RTCA Special Committee 186, Working Group 5

ADS-B UAT MOPS (DO-282), Revision A

Teleconference on 1.12.04

Proposed Changes to the Test Procedure of §2.4.2.4 Resulting from the Addition of the Requirement for the Horizontal Eye Diagram

Figure 2-11: Digital Demodulation Mode – Trace C: "Eye Diagram"

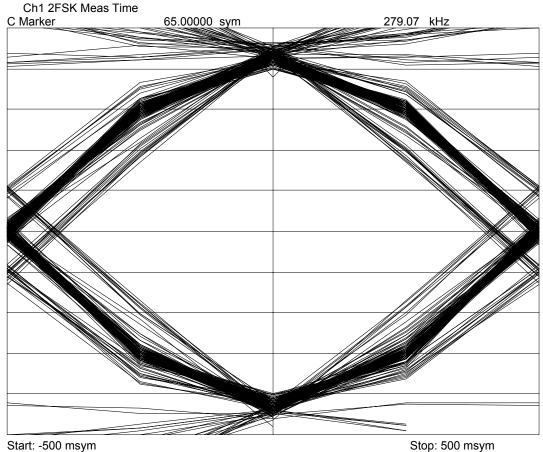
This Working Paper contains the proposed changes to the test procedures of §2.4.2.4 as a result of the changes previously agreed to by WG-5 for the addition of a new paragraph in §2.2.2.4, specifying the requirement for the horizontal eye diagram. Additionally, a change was required for Figure 2-11 as a result of the change from the "Root Raised Cosine" filter to the "Low Pass" filter.

Connect the ADS-B Transmitting Equipment to the Vector Signal Analyzer through enough attenuation to present a signal at the Vector Signal Analyzer input of -60 ± 5 dBm, and initiate a series of Long ADS-B test messages each having the following message elements: the 36 bit SYNCH, followed by a 272 bit Payload having a pseudo-random series of bits which changes for each successive payload, and a 112 bit FEC as generated by the Reed-Solomon algorithm. On the Trace C "Eye Diagram," find the minimum upper crossing, and the maximum lower crossing, at the horizontal center of the display, and verify that the upper crossing minus the lower crossing is no less than 560 kHz (8 vertical divisions). Trace C should resemble Figure 2-11.
